PREFACE (INCLUDING RESPONSES TO COMMENTS)

The City of Riverside (City), through its Community & Economic Development Department, Planning Division (Department), is the lead agency responsible for the review and approval of the proposed Street Light Replacement for Areas 3–5B Project (project or proposed project). The City has made the determination that a mitigated negative declaration (MND) is the appropriate environmental document to be prepared in compliance with the California Environmental Quality Act (CEQA). Similarly, MNDs were prepared and approved for the previous lighting phases of Area 1 (Planning Case P12-0043) and Area 2 (Planning Case P15-0344) in 2012 and 2015, respectively. Based on light complaints from Area 1 of the Wood Streets Street Light Project, the need for tree trimming in some areas, and the potential for sidewalk detours during light replacement activities, mitigation measures were incorporated into the previous Area 2 phase. Similar mitigation measures are proposed for Areas 3–5B of the proposed project to ensure impacts are less than significant.

Street Light Replacement for Areas 3-5B Project

INTENTIONALLY LEFT BLANK

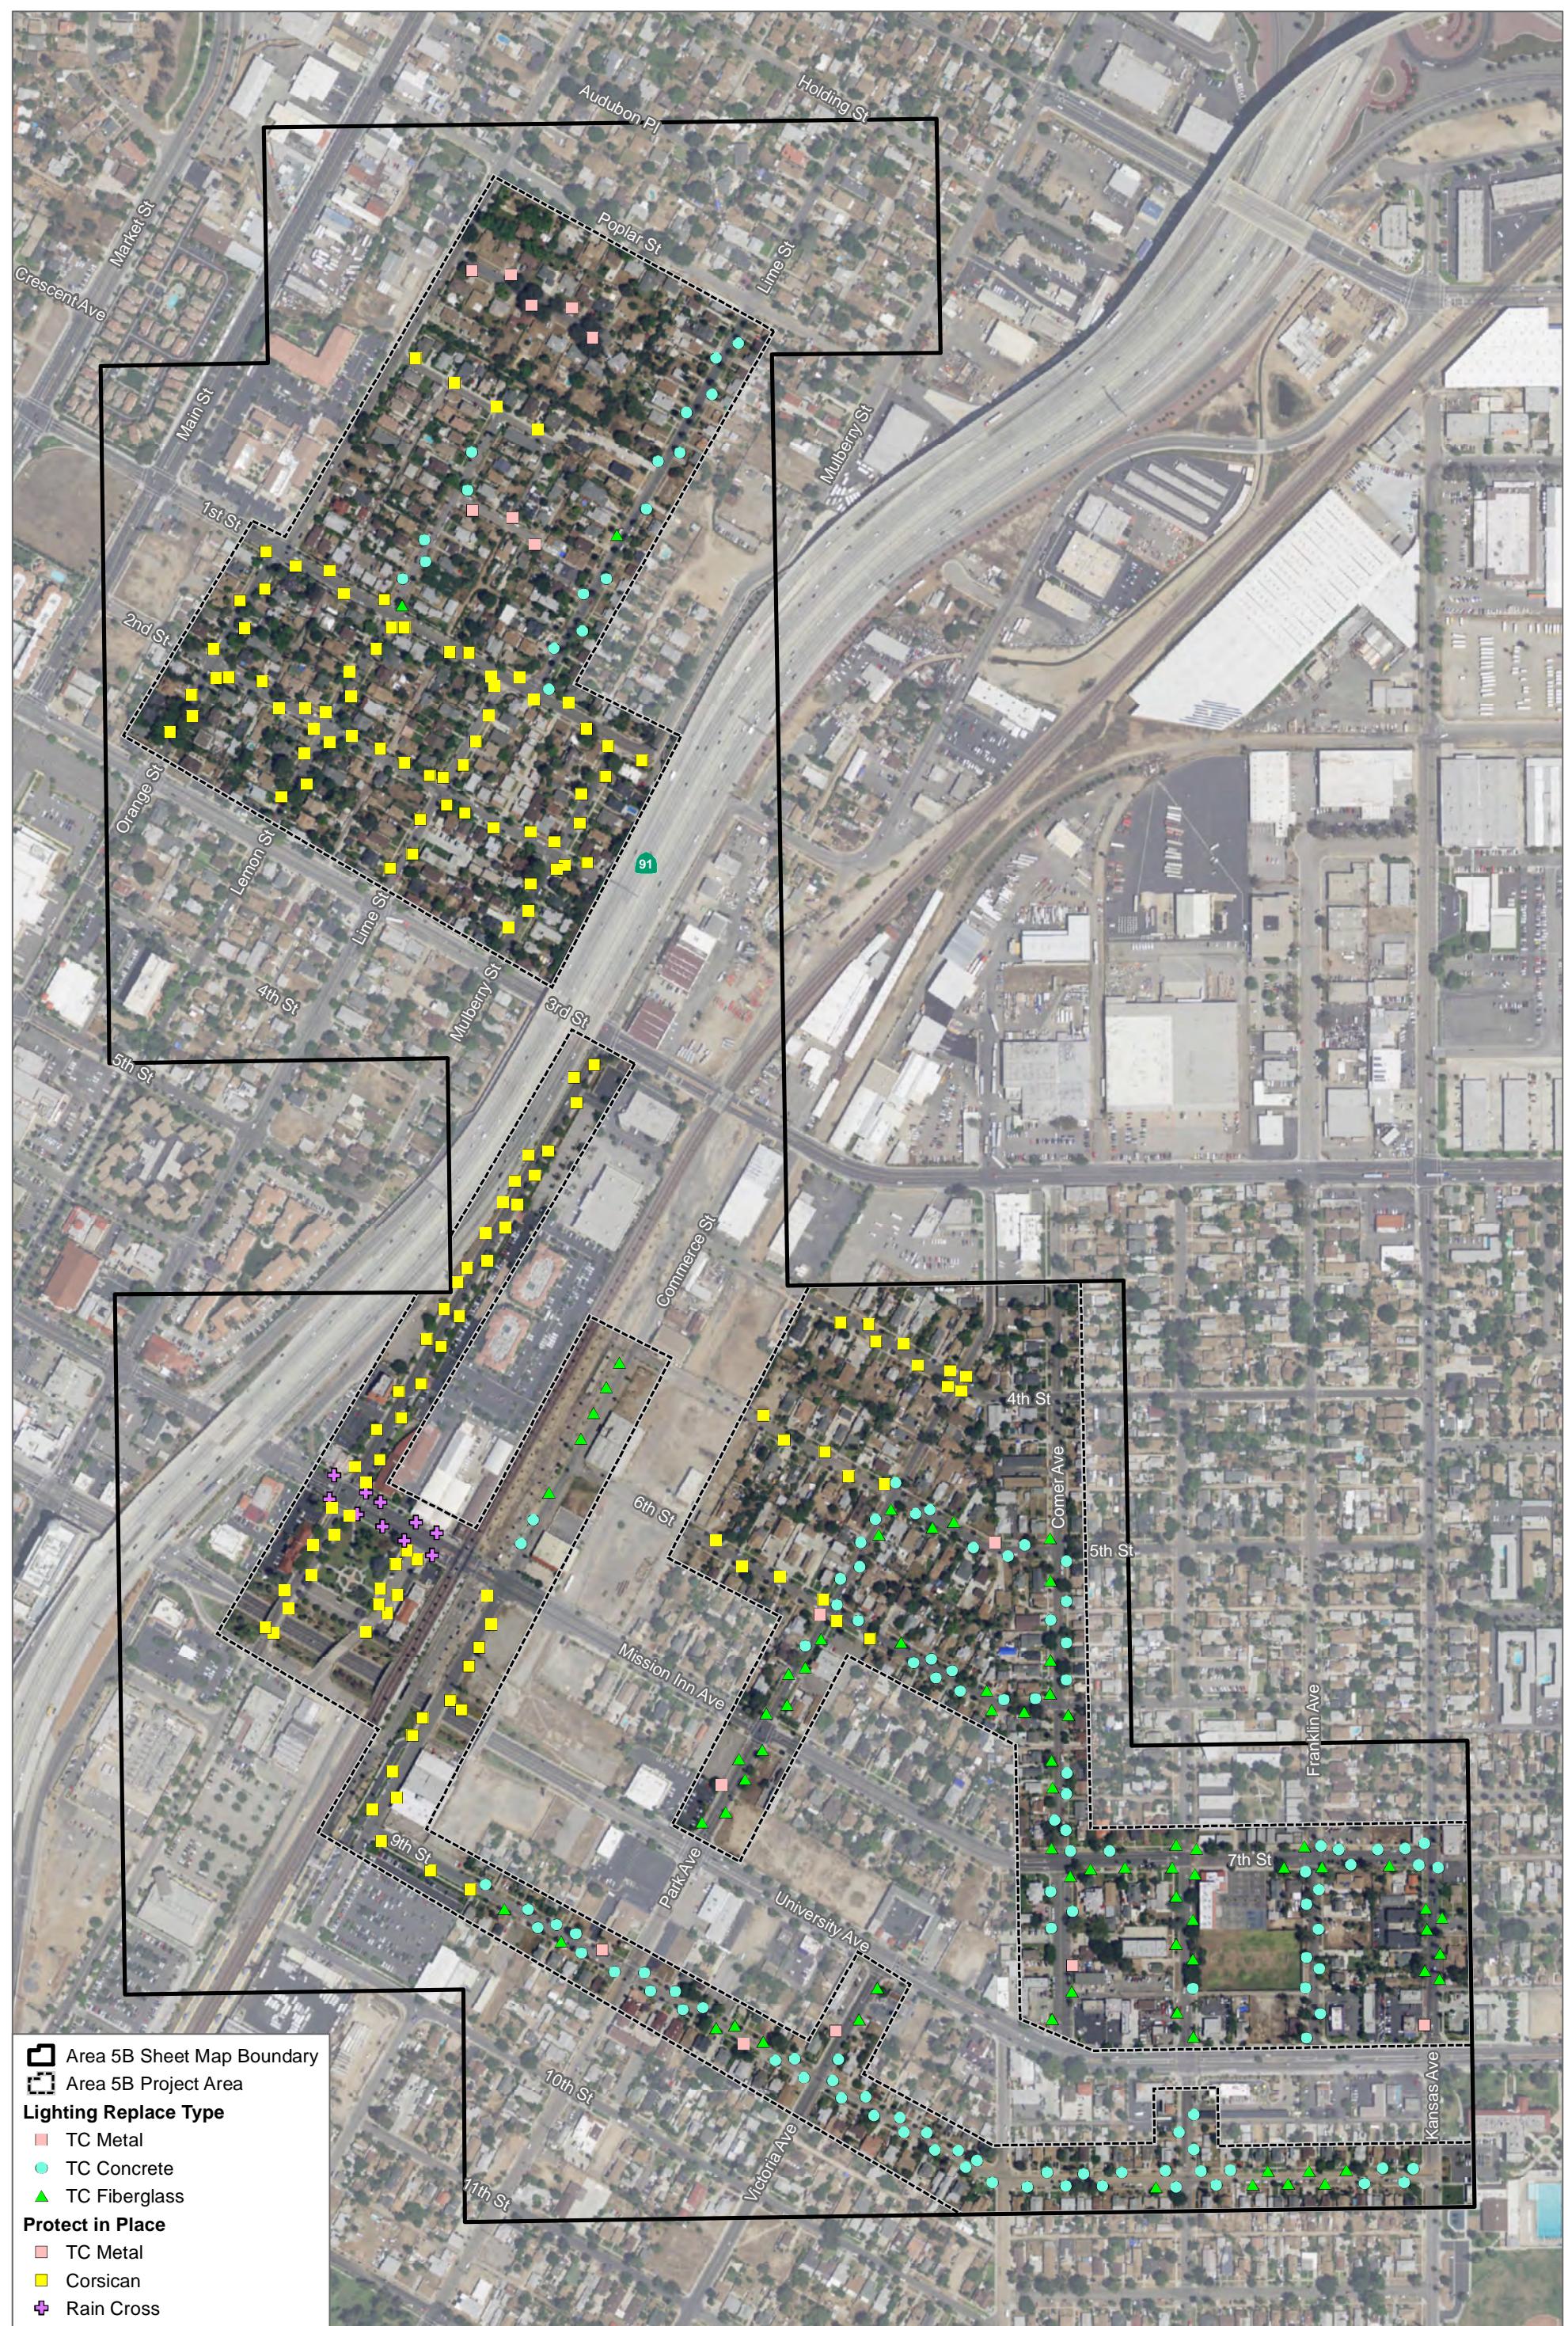
A-1 The commenter expresses concern regarding the height and location of the proposed streetlights, and potential impacts this may have on airplane hazards. Figures 3 through 7, included in the IS/MND, show all locations where the streetlights would be replaced. As discussed in IS/MND Section 4.2.5a, the proposed number and spacing of streetlights is based on American National Standard Practice for Roadway Lighting ANSI/IESNA RP-8 (RP-8), the standard approved by the Riverside City Council in 1996. As advances in lumen output technology have been made since installation of the existing historic streetlights, RP-8 Standards would actually reduce the number of streetlights needed per block to provide required lighting levels. Thus, the proposed project is expected to result in fewer streetlights than currently exist in Areas 3 through 5B. Provisions of the City's historic preservation ordinance, Title 20, the Secretary of the Interior's Standards for the Treatment of Historic Properties related to historic resources and design standards and guidelines, require that replacement streetlights look similar to existing ones. Thus, it is expected that replacement streetlights would be similar in height to existing streetlights. More specifically, the design details of the proposed replacement streetlights, including the proposed height of the streetlights, have been incorporated as Figure P-1, Replica Kodiak Replacement Streetlights Details, and the design details of the proposed luminaires have been included as Figure P-2, Proposed Luminaire Details. As shown in these figures, the standard and luminaire, together, indicate a total installed height of 14 feet and 3.5 inches. It should be noted that the height of the proposed replica streetlights is approximately 2 inches taller than existing streetlights. However, the existing direct embedment historic streetlights currently vary in height for a variety of reasons, such as the depth of the original excavation at the time of installation, soil compaction, minor changes in parkway elevation due to landscaping changes, settlement, and intrusion by tree roots. It should also be noted that although not all the streetlights would be replaced in the exact same location as the existing streetlights, replacements would be made in the same general locations (either adjacent to or across the street from existing streetlights). Further, the proposed streetlights are not expected to exceed the heights of other structures in the areas, including two- to three-story existing structures in the area, telephone poles, palm trees, etc. Lastly, as discussed in Section 4.2.8d, although part of the project site is located within Compatibility Zone "Other Airport Environs" of the Riverside Municipal Airport, only uses that would be hazardous to flight (such as tall structures) are prohibited within this zone.. The City provided additional information regarding the height and location of the proposed streetlights to the commenter on October 3, 2018, and November 1, 2018.

B-1 Based on the information provided by the City, the commenter confirms that the height of the proposed streetlights are below the Federal Aviation Administration's threshold for height obstacle obstruction, and thus no potential issues regarding flight hazards are expected. No further response is required.
